**AUTOTRANSFORMER-TYPE STARTERS
AND COMPENSATORS
GENERAL ELECTRIC COMPANY
REPLACEMENT PARTS AND PROCEDURES**

1.001 This addendum supplements Section 026-305-801, Issue 4. The added pages must be inserted in the section in accordance with the filing instructions above.

1.002 This addendum is issued to add information covering the CR2820-B130AA pneumatic time-delay auxiliary contact.

Fig. 14 – CR2820-B110AA and CR2820-B111AA Pneumatic Time-Delay Relays (CR2820-B111AA shown)

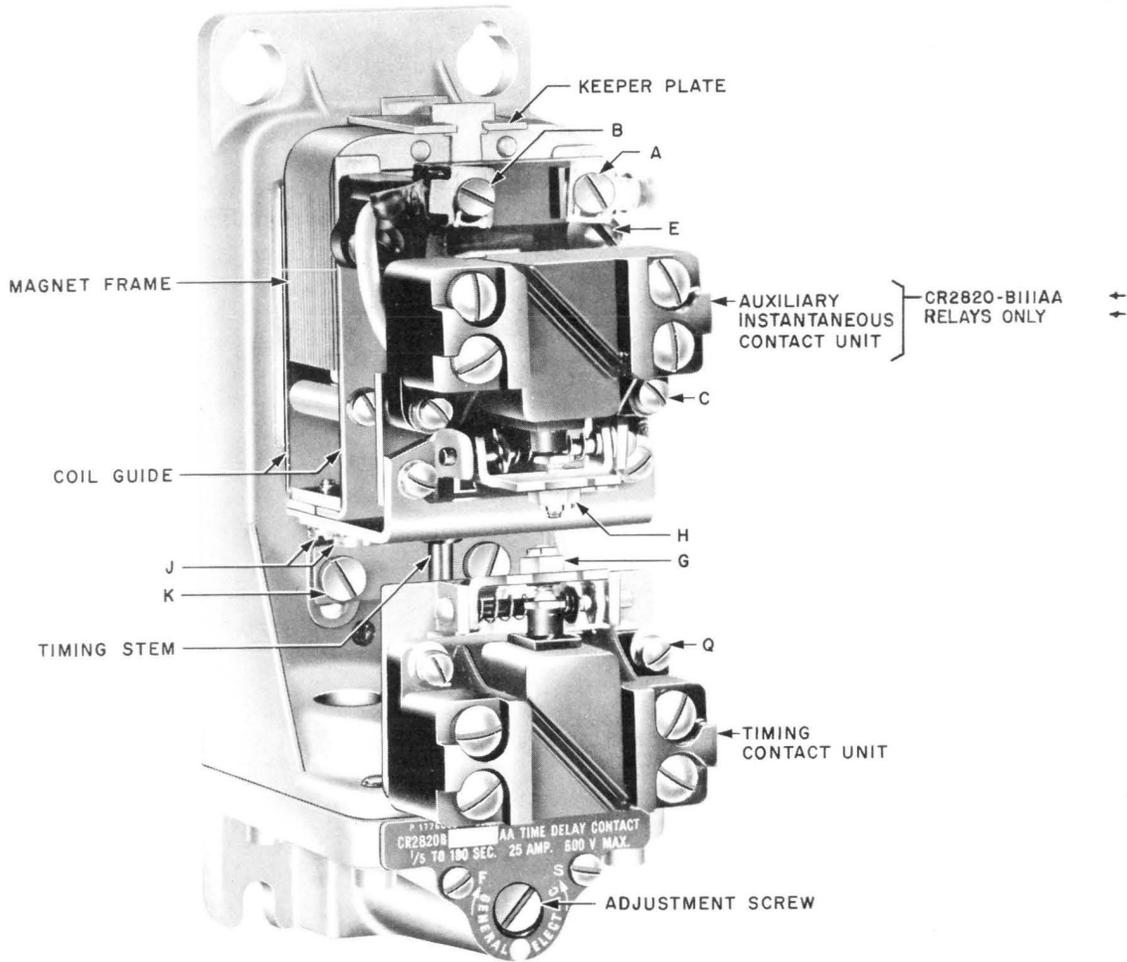
3.04 CR2820-B130AA Pneumatic Time-Delay Auxiliary Contact

(a) The pneumatic time-delay auxiliary contact is similar to the lower half of the relay shown in Fig. 14. It consists of a timing stem, timing contact unit, and pneumatic head and frame. The pneumatic time-delay auxiliary contact is a component part of a start contactor by which it is actuated.

(b) **Timing Contact Unit** (see Fig. 14): To replace the timing contact unit, remove screws (Q) which will release the contact unit from its mounting bracket. Reassemble the new contact unit with screws (Q) and adjust screw (G) as indicated in step (c).

(c) The timing contacts should operate when the timing stem is approximately 1/16 inch from the end of its stroke. If not, screw (G) should be readjusted until 1/16-inch operation point is obtained. The timing head should at no time be disassembled.
